# SPECIAL AIRWORTHINESS INFORMATION BULLETIN

CE-06-04  
October 18, 2005

**Service Bulletin Number: SB-003**

**Subject: Vacuum Pump Replacement.**

**AA3216CW Shown, Others similar**

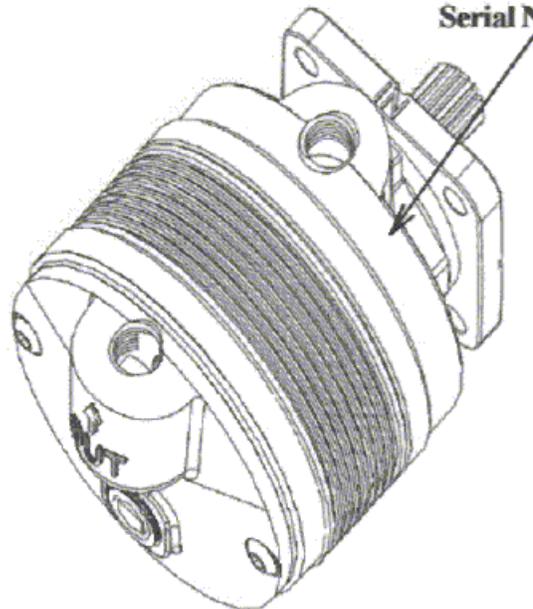
To identify affected pumps, check the model and serial number decals located on the periphery of the pump's front cover. If the model and serial number of the pumps(s) falls within the ranges listed on page 1, the pump is affected and must be replaced. If the serial number is obliterated, call Aero Accessories, Inc. at 1-800-822-3200 for assistance.
